Development Permit Panel Electronic Meeting

1. **DEVELOPMENT PERMIT 25-022217**
(REDMS No. 8526991)

PROPERTY LOCATION: 9620, 9640, 9660 and 9700 Alberta Road

That a Development Permit be issued which would permit the construction of 29 townhouse units at 9620, 9640, 9660 and 9700 Alberta Road on a site zoned "Medium Density Townhouses (RTM3)".

A2

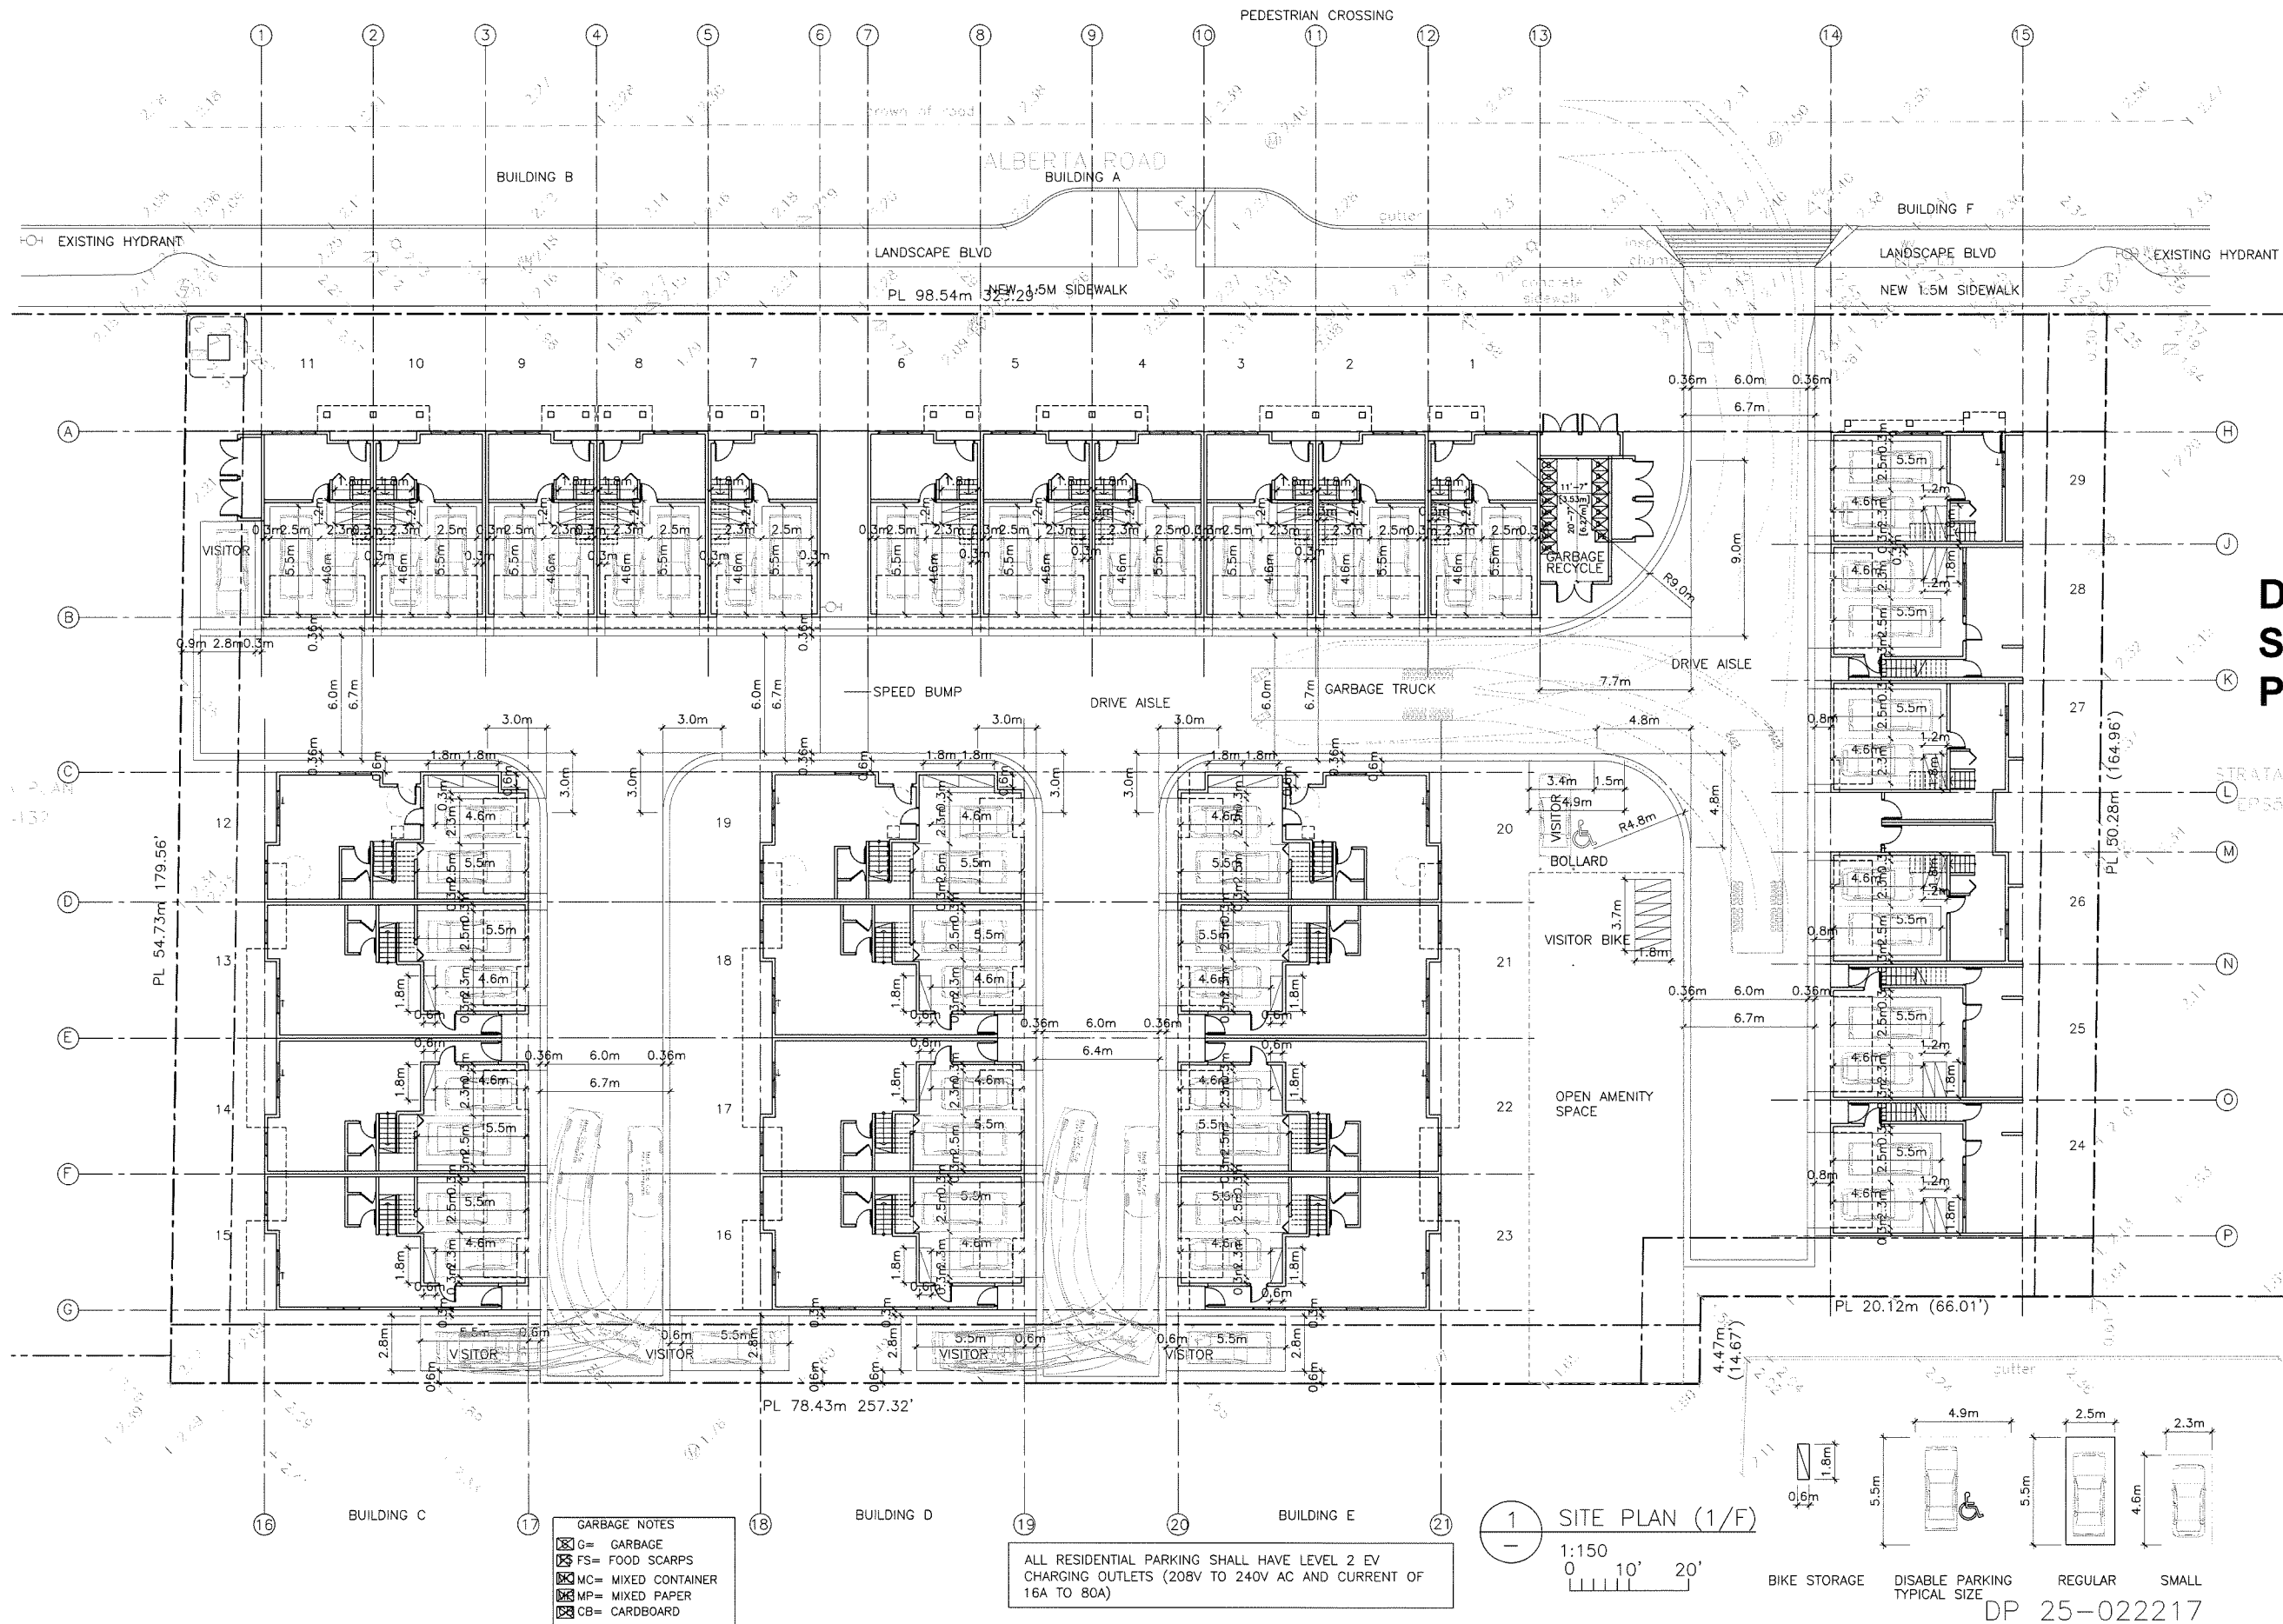
- consider adding bollards for the electrical closet; ***the electrical closet is relocated to building A as shown on site plan A2***
- consider a gravel path or another alternative landscape form for the narrow (8 ft.) green space between Building A and Building B; pavers that are currently included in the landscape plans are not practical for lawnmowers and other equipment; consider something simple that might serve the function better; ***gravel path with paver are provided in the narrow space between building A and B in the landscape drawings***

- consider adding a bollard in the northeast corner of the outdoor amenity space as the garbage truck would come through that area and use that drive aisle to turn around; ***the disabled parking is moved to the drive aisle intersection and the open amenity space is moved away from the drive aisle intersection. Bollard are provided behind the disabled parking as shown on site plan A2***

- consider installing speed bumps in the drive aisles for safety; ***a speed bump is added and indicated on architectural site plan A2***
- concerns about the hedges on either side of the northeast opening into the mailbox and play area; this can pose a risk as children may run out from behind these hedges and in front of a vehicle; ***The open amenity space is moved back away from the drive aisle intersection.***

L1

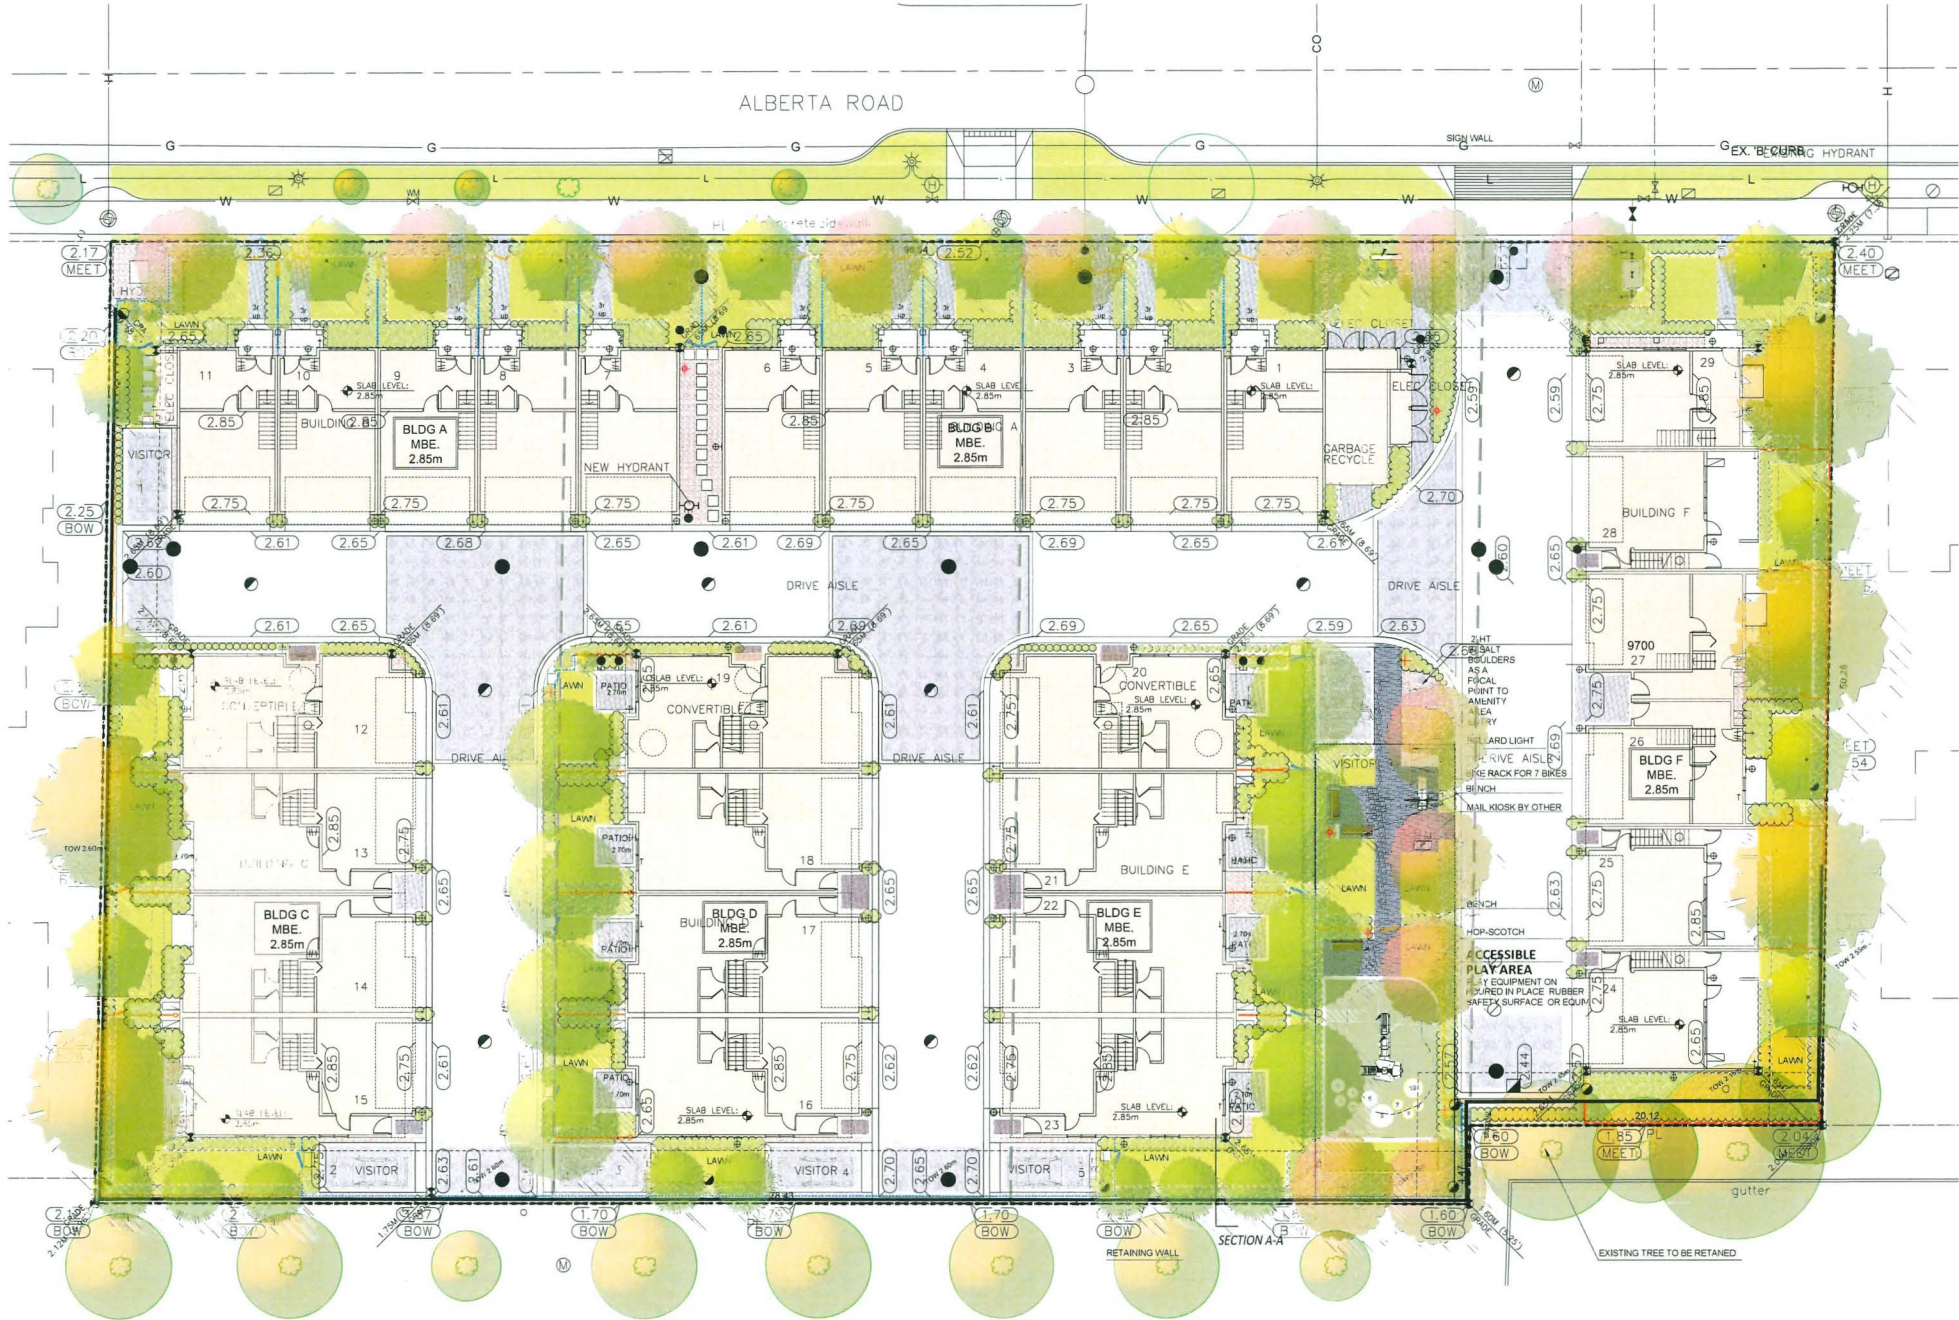
- consider a low light or bollards for the 8 ft. wide gap between Building A and Building B as pedestrians may use that area to walk through even if that is not the intended purpose; ***landscape bollard lights are shown on the landscape drawing L1***

- agrees that the tree species selected should be revised based on the urban tree list for Metro Vancouver; consider selecting more suitable trees for the area; ***The tree species are revised as shown on L1***

- consider a large deciduous tree for the south edge of the property; the current planting plan includes big conifers that may block southern sunlight for adjacent yards; ***The tree species are adjusted as shown on L1***

- examine opportunities to maintain consistency in the gable design; if windows are not feasible, consider using covered or solid treatments to reinforce the gable articulation; ***A bay window is added on building B end elevations as shown on A8***
- agree with the recommendation to improve consistency and repetition of architectural elements, specifically the gable forms; and ***roof pitch adjusted as shown on elevations A9***
- consider incorporating strategic bollard lighting or similar pedestrian-scale lighting that can improve safety within the development; ***Bollard lighting is indicated as shown on L1***
